## Economic Commission for Europe

#### Working Party on Lighting and Light-Signalling

## **Proposal for the 06 series of amendments to Regulation No. 10 (Electromagnetic compatibility)**

### **Submitted by the Task Force on Electromagnetic Compatibility (TF EMC)\***

**Figure 1**

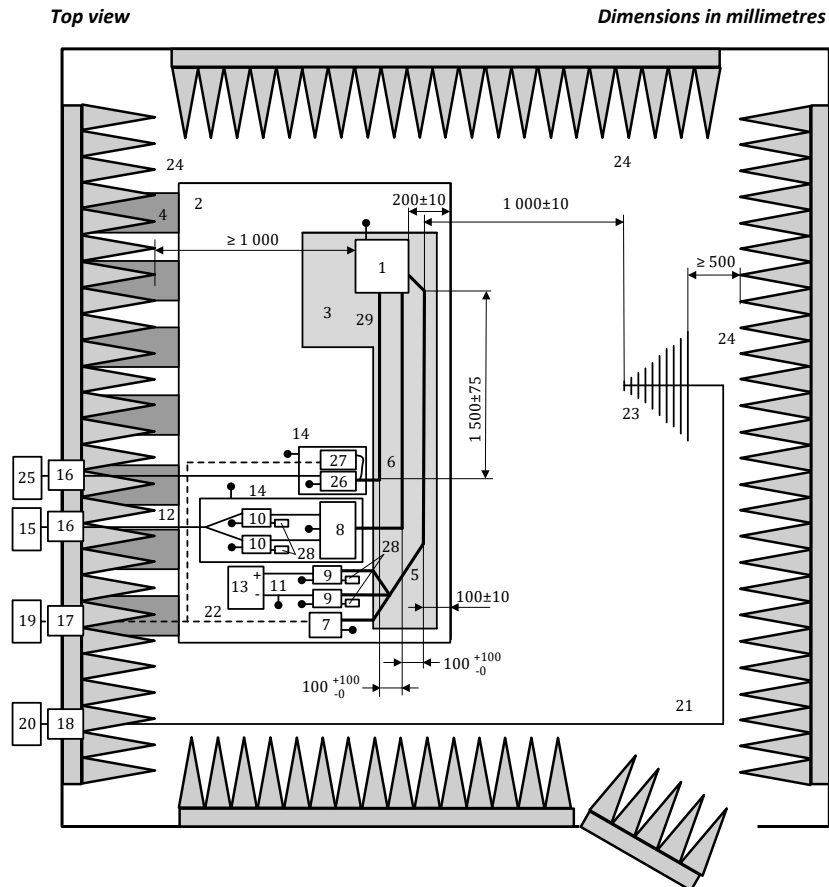
Annex 9, appendix 3, delete and replace by:

Test configuration for ESA's involved in "REESS charging mode coupled to the power grid". The test shall be performed according to ISO 11452-2.
